Nº 137 SERVICE BULLETIN

SUBJ: Austin Powers CPU Game ROM v3.01 Bug.

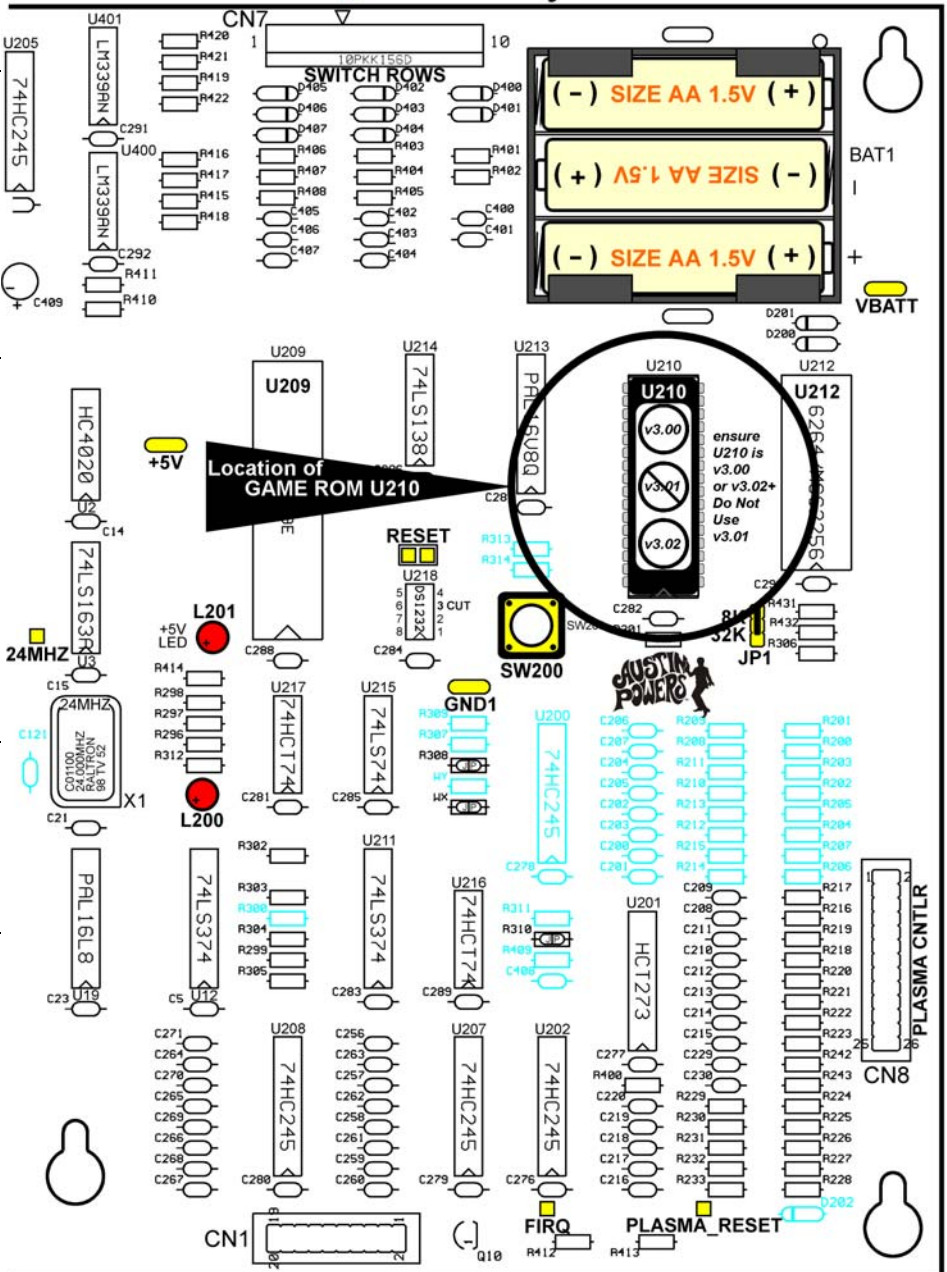
With CPU/OPSYS EPROM (Game ROM) **U210 v3.01** in place on the CPU/Sound Board: If the player does not achieve (score) the **Skill Shot*** and the ball subsequently drains, the ball will be put back in play repeatedly without advancing to the next ball. * **Austin Powers Skill Shot:** *The opening shot from the plunger at the beginning of each ball, closing either Top Lane Switch #47 or Switch #48.*

This version of software had an unforeseen bug which has been exterminated in v3.02. **This is a software problem ONLY with version 3.01.**

Replace only the **Game ROM** with v3.02 in the **U210** position on the **CPU/Sound Board**. This Game ROM is available from our distributors or can be downloaded for free from our web site. *To find a local distributor or to download, visit www.sternpinball.com.*
